Access Compliance Report

Public Rights-of-Way

(Curb Ramps)

Intersection ID: 24591	Main Street: REA_CROFT_DR	Cross Street: SPRINGSIDE_LN	Location: SE
ADA ID: E40DF4BEF95F	Ramp Type: BlendTrans2	Initial Pass/Fail: Pass	Overall Compliance: No
		Severity Score: 10

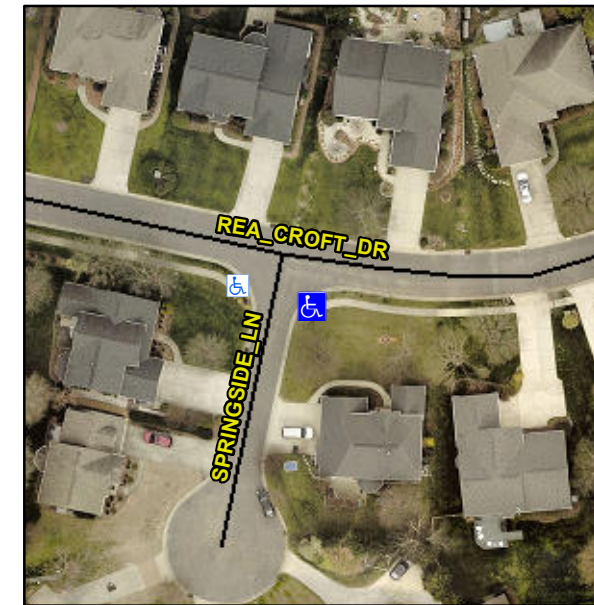
Not Found, R305

N/A	Ramp inside XWalk1?	N/A	N/A	Ramp inside XWalk2?	N/A
	Road Slope (%)	0.7		Clear Space?	Yes
	Road X Slope (%)	4.9	N/A	Clear Space to XWalk (in)	N/A
Yes	Any Obstructions?	No	Yes	Storm Grate/Utility Hazard?	No
	Obstruction Type			Storm Grate/Utility Type	
		N/A			N/A
			Yes	Surface Condition? (G/P)	Good
			No	Curb Slope (%)	12.2

Remove & Replace Curb Ramp With Two New Directional Ramps or Equivalent.
